SUBJECT: Forwards design change for power ^{see Ref 15} supply to MSIV actuator solenoids, per IEEE 279 & GDC 21 to 10CFR50, App A. Response to NRC 870109 concerns also encl. Info will be incorporated into next rev to FSAR.

Re: Nine Mile Point Unit 2
Docket No. 50-410

REVISED MSIV ACTUATOR CONTROL POWER SCHEME

RPS / MSIV POWER SUPPLY

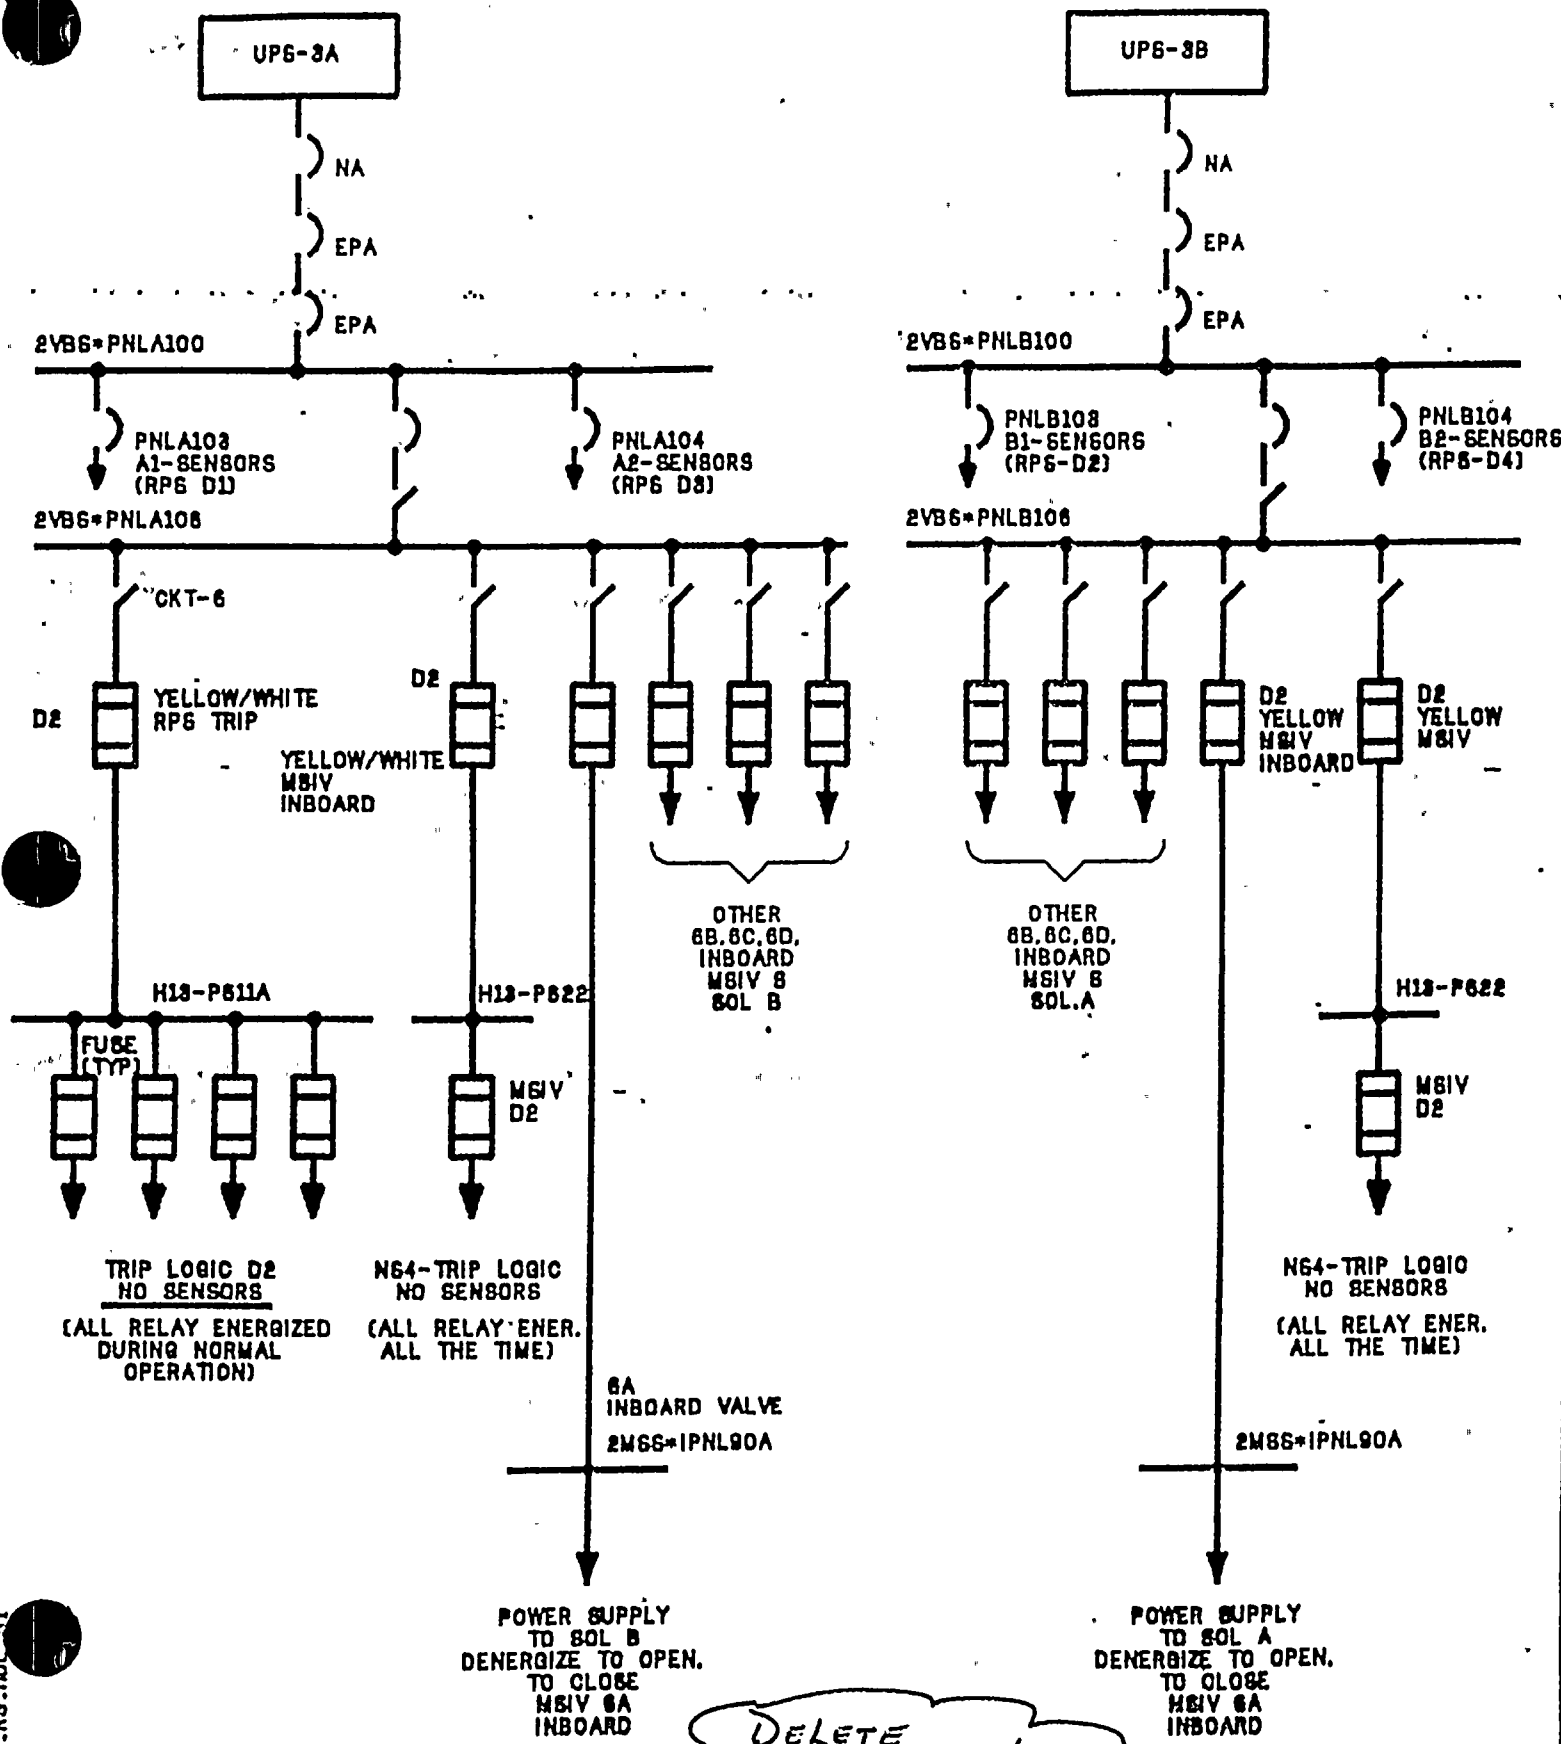
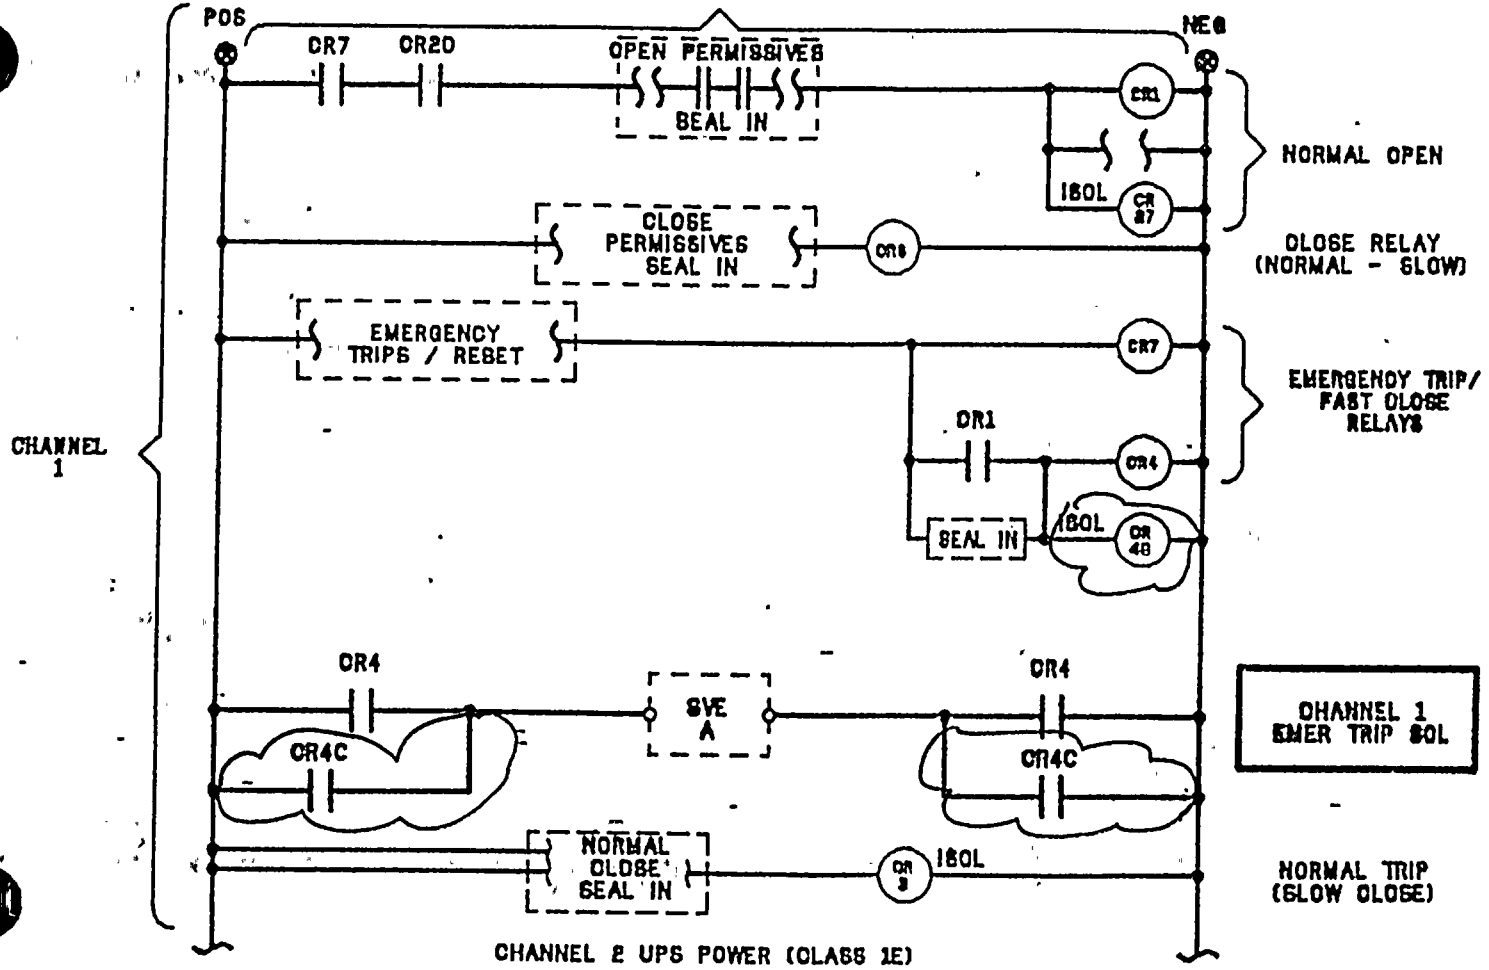
DELETE
POWER Transfer

*DELETE
POWER Transfer*

The attached sketches show the revised method of supplying the electrical solenoids associated with the MSIVs. No transfer will exist between UPS3A and UPS3B. In addition, the transfer that formerly existed to test the solenoid (SVC) has also been removed. Therefore, if either UPS supply is lost, no transfer will occur.
